ADDENDUM No. 1

Hoover, Greene, & Hill Improvement Project

ADDENDUM No. 2

Hoover, Greene, & Hill Improvement Project

STAGE 1D:
 NB MAIN ST CLOSURE AT HOOPER
 NOTE: WORK MUST OCCUR IN ONE WEEKEND. WORK ZONE MUST BE SAFELY OPEN TO TRAFFIC AT THE END OF THE DAY. THIS CLOSURE WILL OCCUR WHILE THE NB HOOPER AVE DETOUR IS IN PLACE.

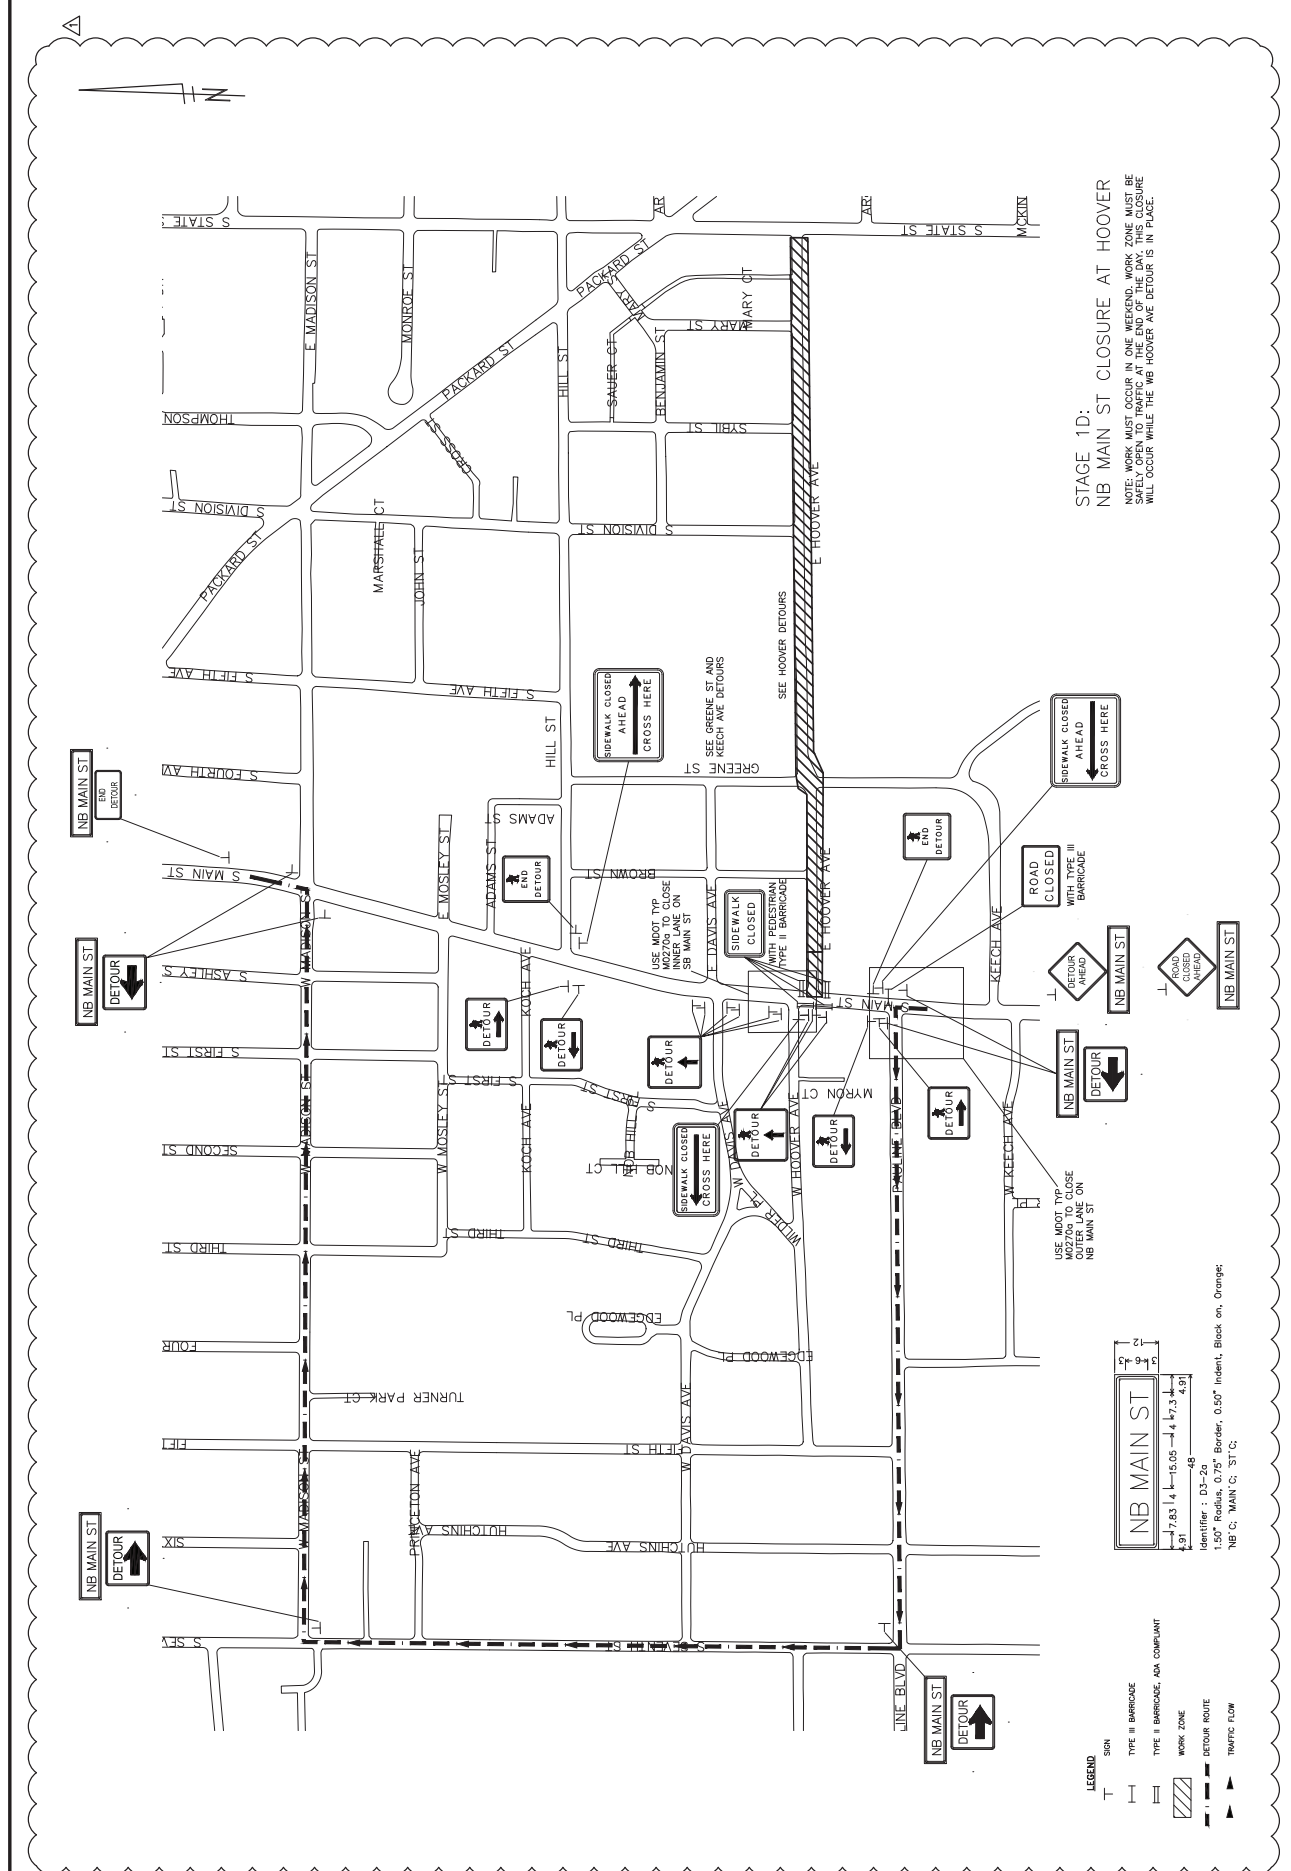
Plan Sheet 74 of 83 Remove sheet 74 and replace with "Main Street MOT at Hoover" plan sheet 74 dated 02/22/19 and designated Addendum No. 2 (copy attached). Changes as noted on sheet.

Comment: The plan sheet has been revised for the extended construction timeframe and staging changes.

STAGE 2A:
 KEECH/GREENE: EAST SIDE CLOSURE
 SB GREEN TRAFFIC MAINTAINED ON WEST SIDE,
 NB GREENE TRAFFIC DETOURED

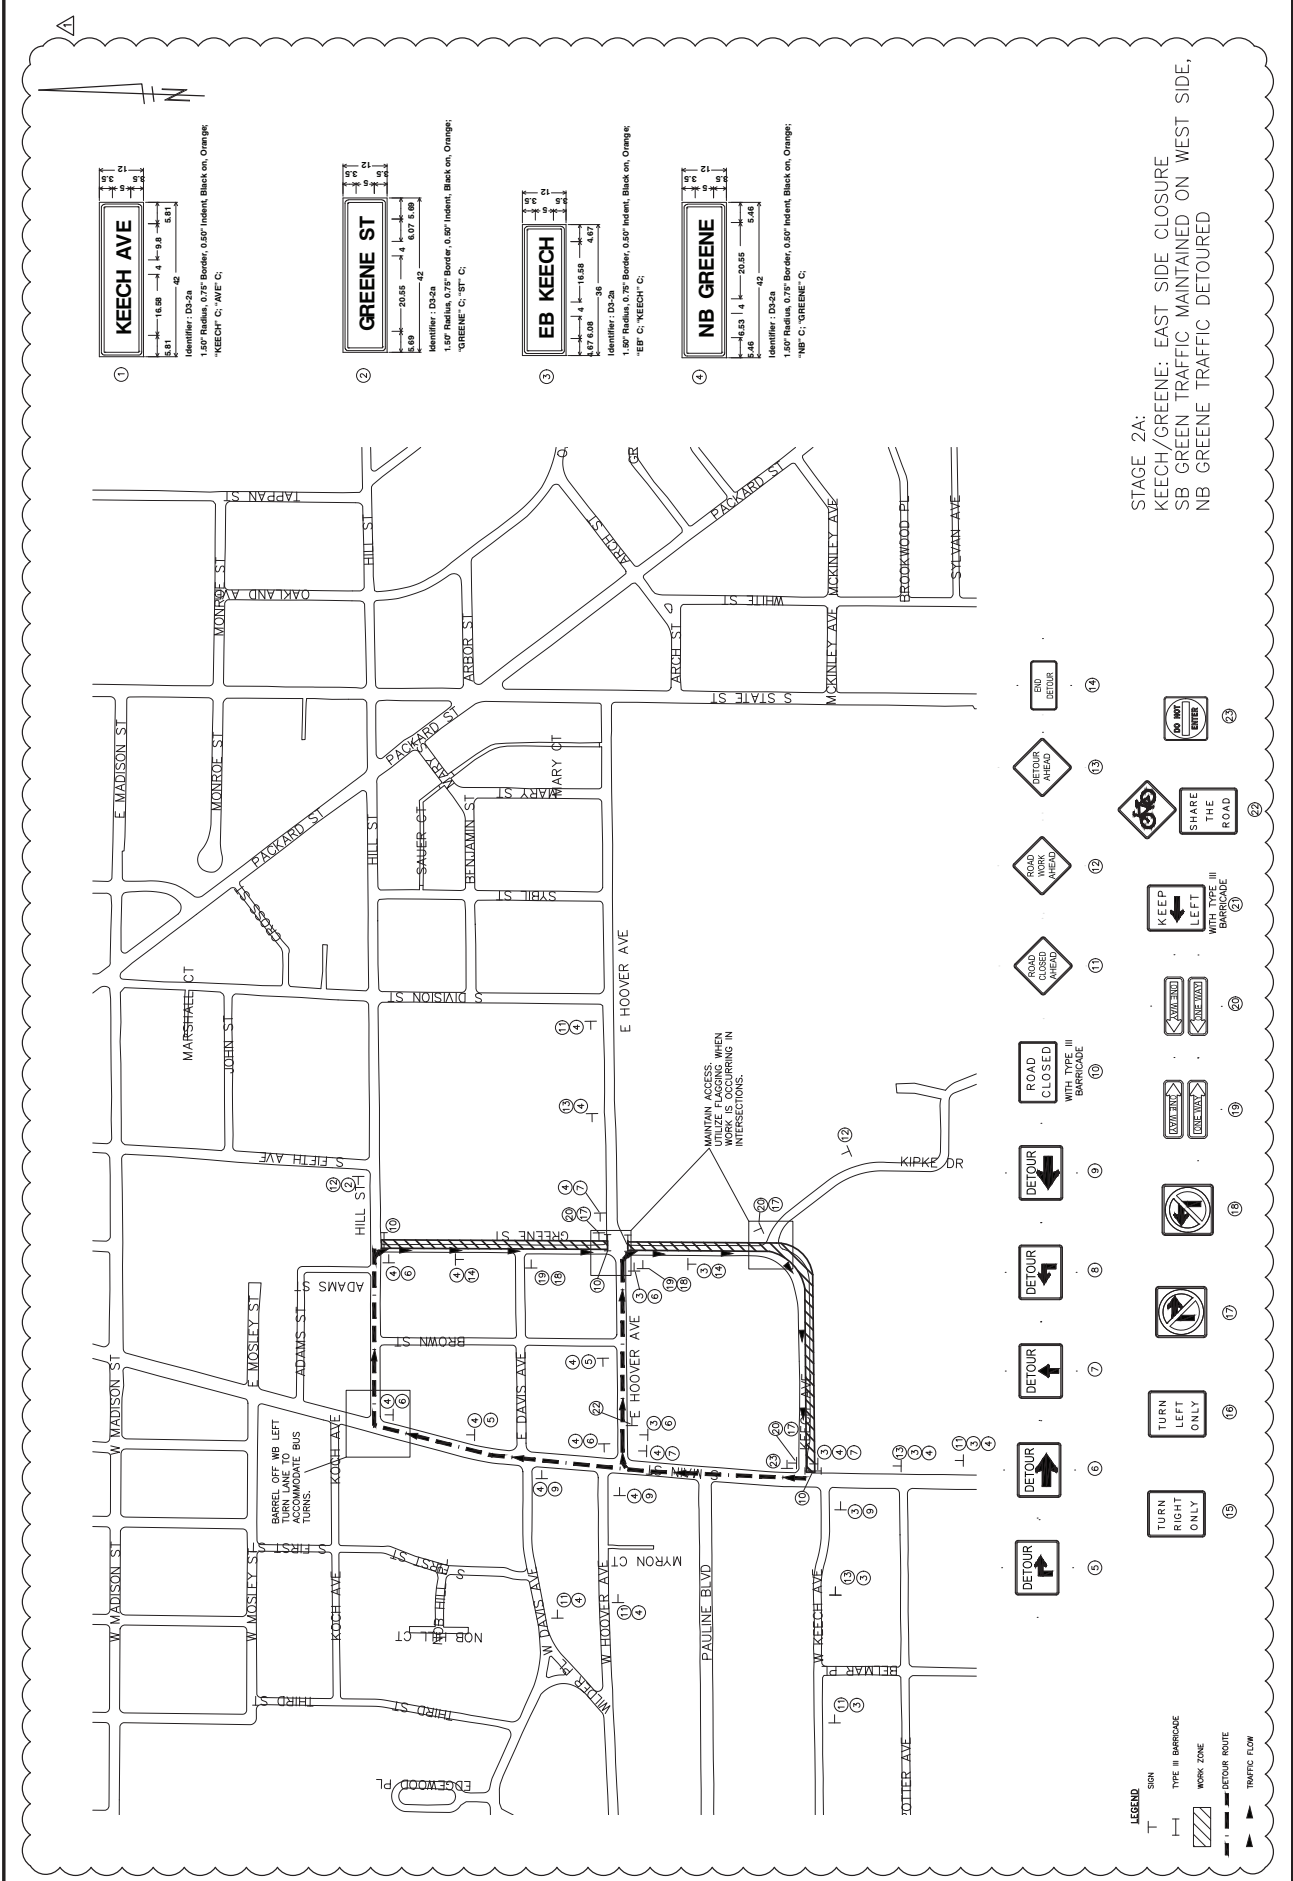
Plan Sheet 76 of 83 Remove sheet 76 and replace with "Keech-Greene MOT Southbound

Lane” plan sheet 76 dated 02/22/19 and designated Addendum No. 2 (copy attached). Changes as noted on sheet.

Comment: The plan sheet has been revised for the extended construction timeframe and staging changes.

STAGE 2B:
 KEECH/GREENE: WEST SIDE CLOSURE
 SB GREEN TRAFFIC MAINTAINED ON EAST SIDE,
 NB GREENE TRAFFIC DETOURED

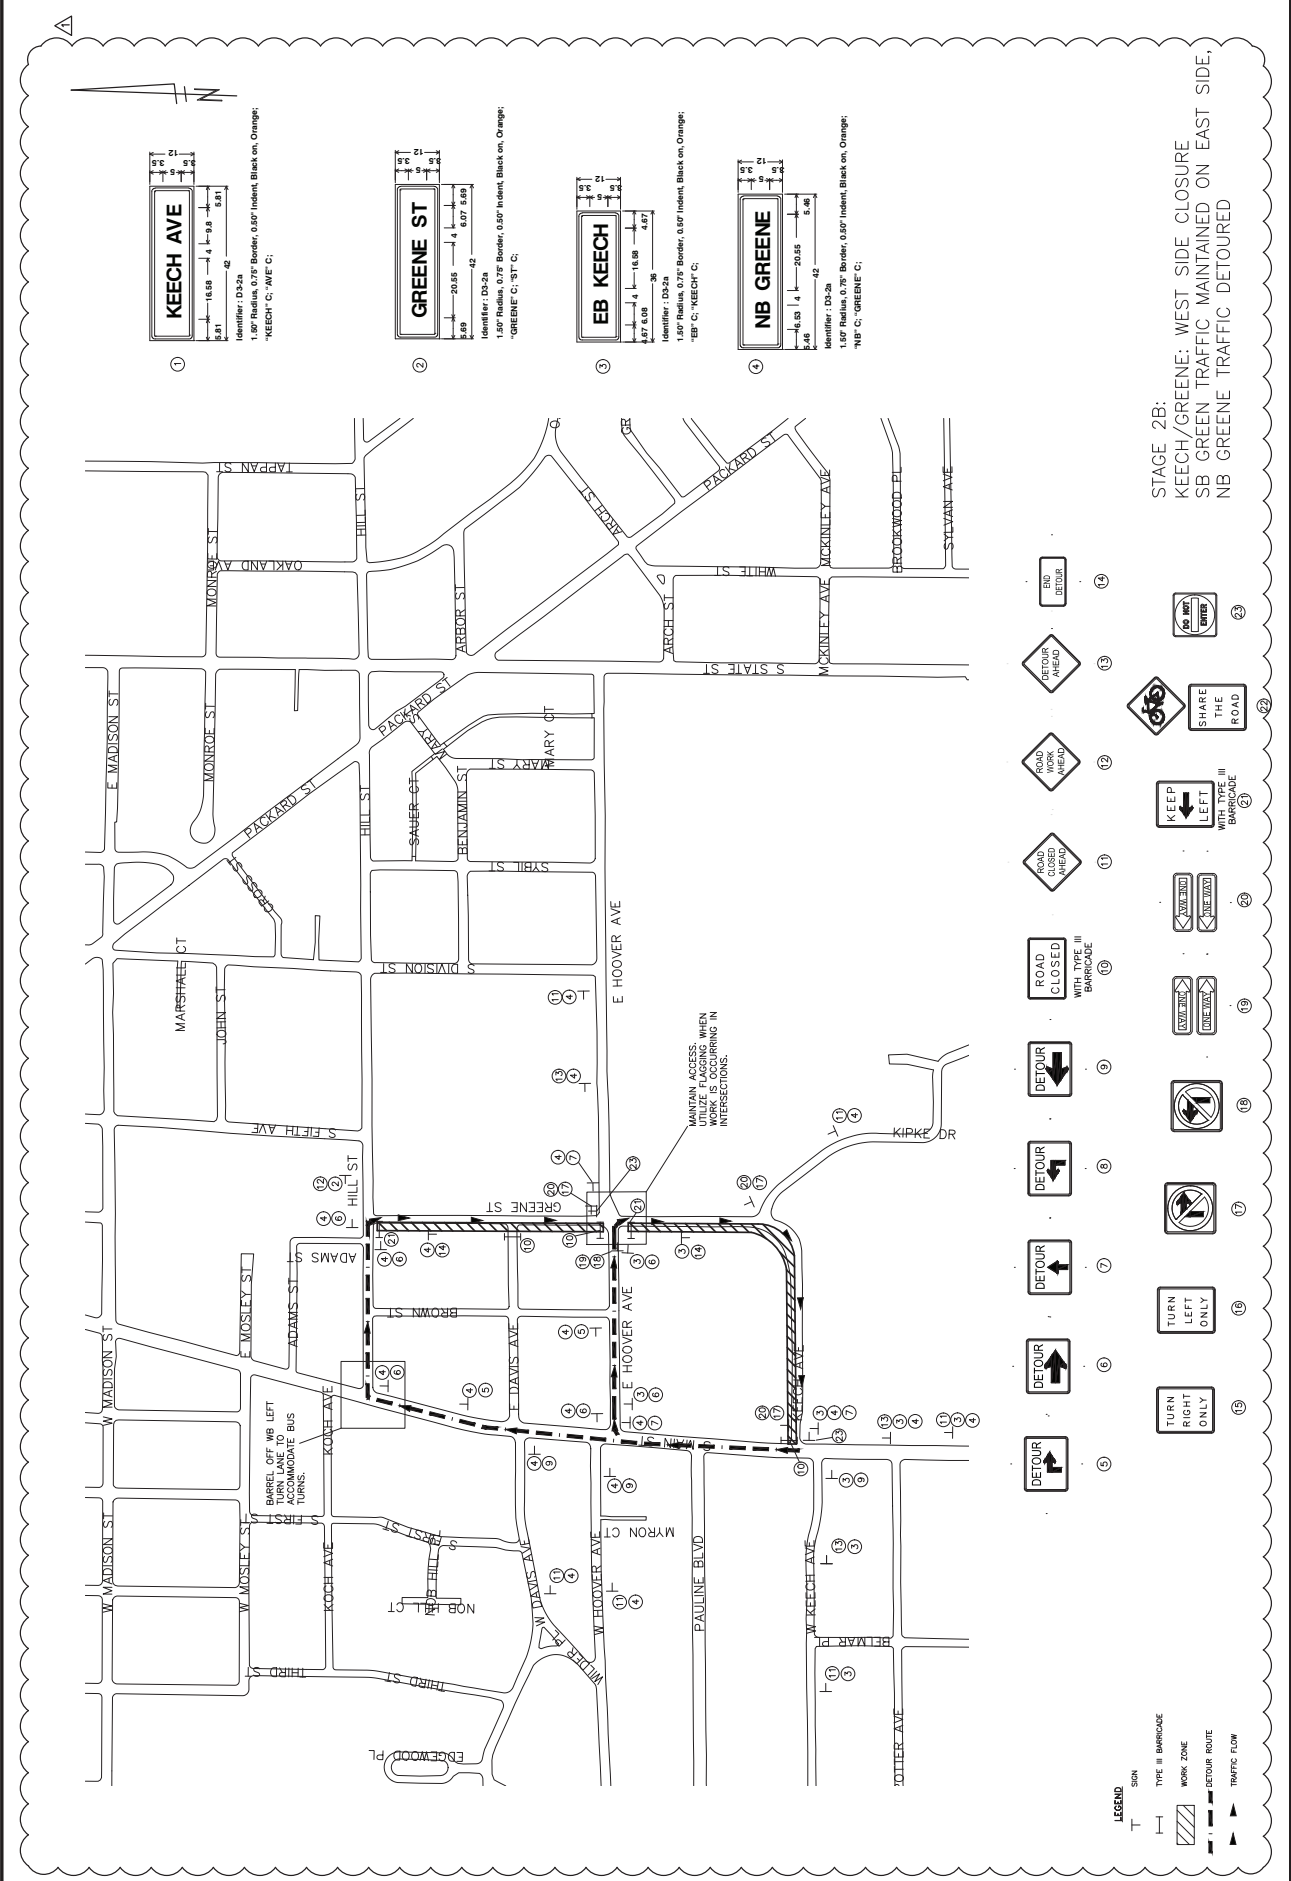
Plan Sheet 76A of 83 Add sheet 76A “Keech-Greene MOT Northbound Lane” dated 02/22/19 and designated Addendum No. 2 (copy attached). Changes as noted on sheet.

Comment: The plan sheet has been revised for the extended construction timeframe and staging changes.

CITY OF ANN ARBOR
PUBLIC SERVICES
HOVER, GREENE, & HILL
IMPROVEMENT PROJECT
HILL STREET DETOUR - FIFTH OPEN

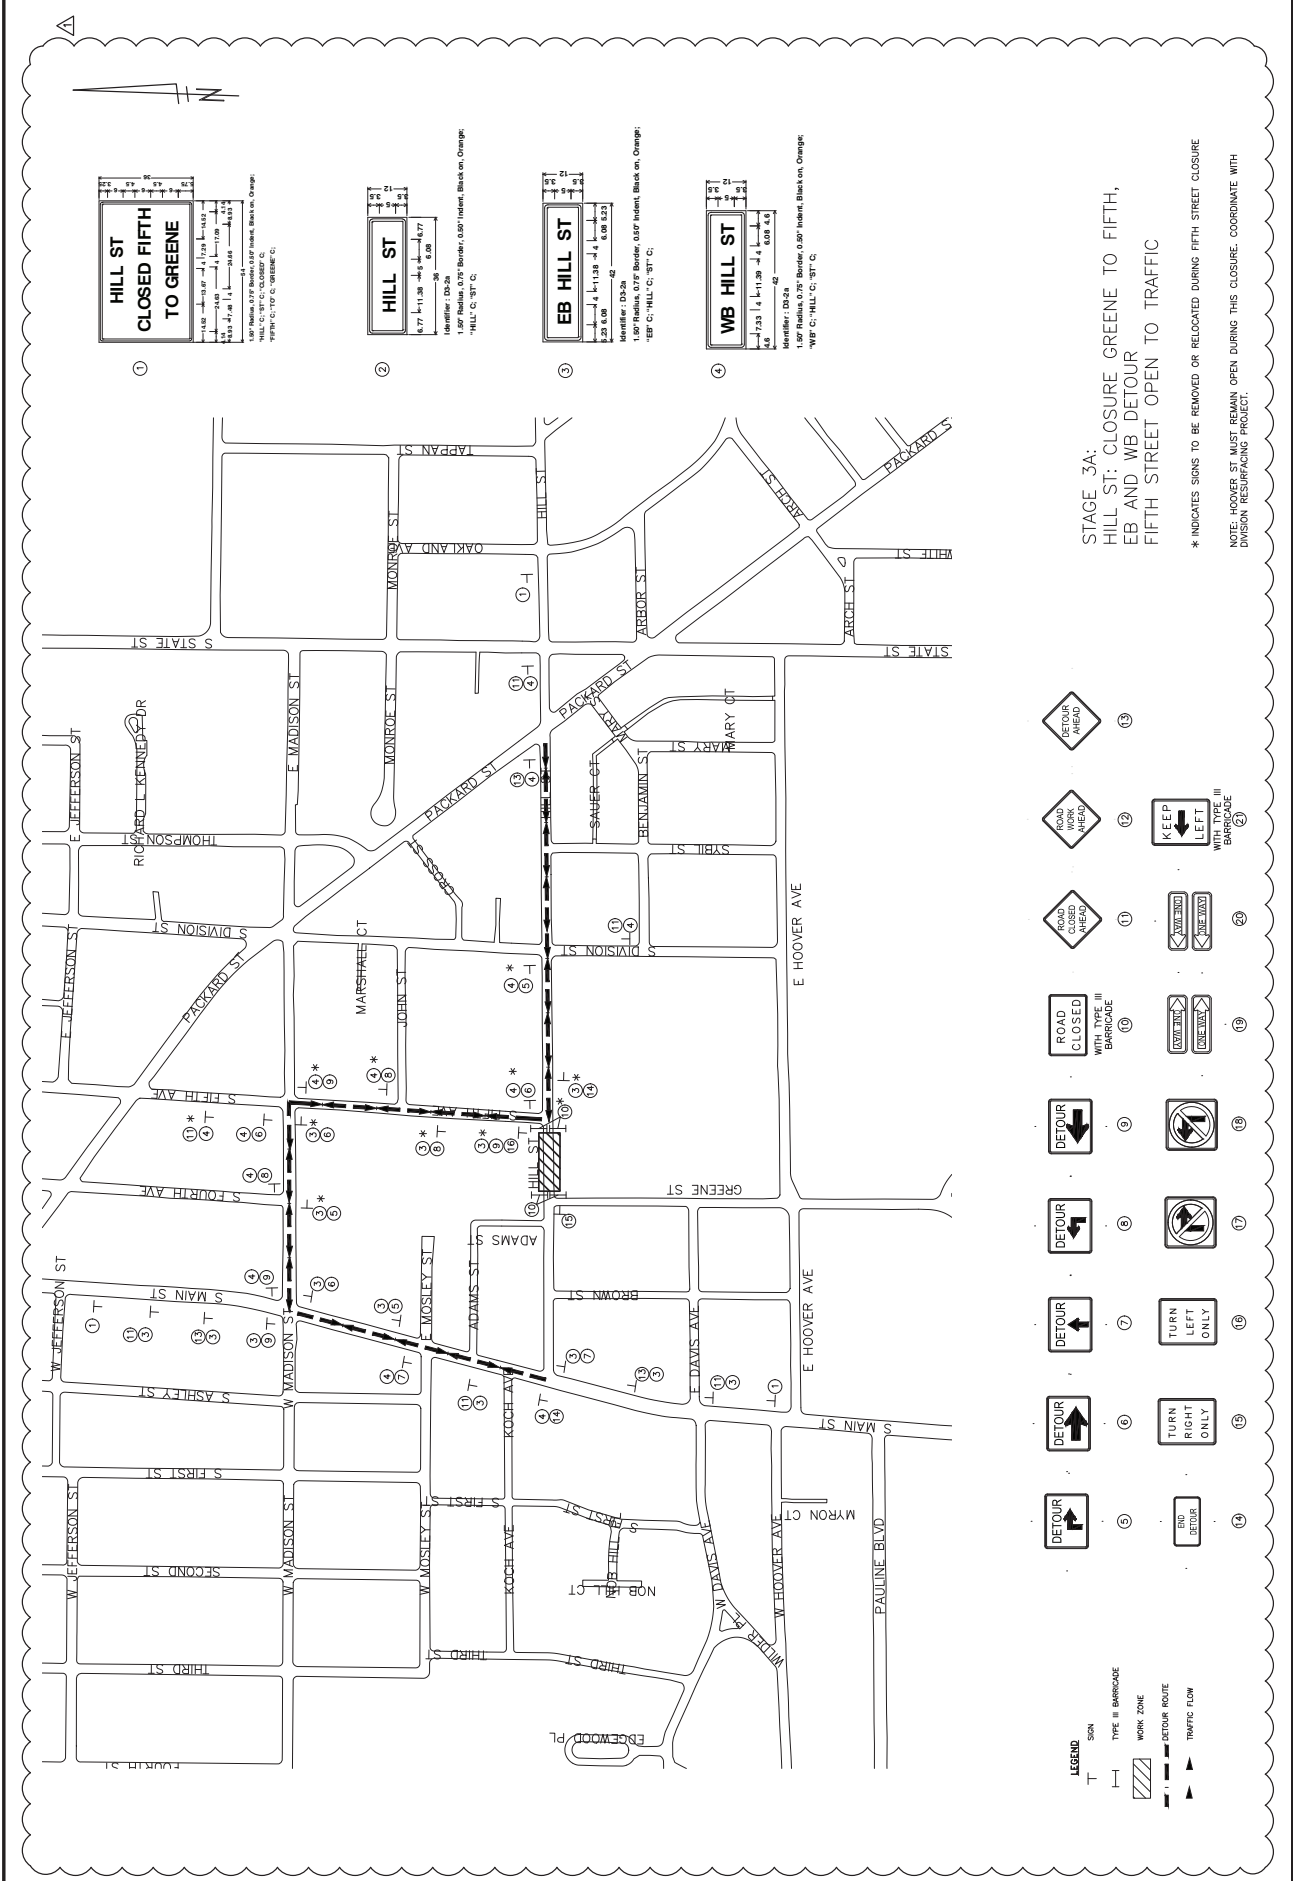
Plan Sheet 77 of 83 Remove sheet 77 and replace with “Hill Street Detour – Fifth Open” plan sheet 77 dated 02/22/19 and designated Addendum No. 2 (copy attached). Changes as noted on sheet.

Comment: The plan sheet has been revised for the extended construction timeframe and staging changes.
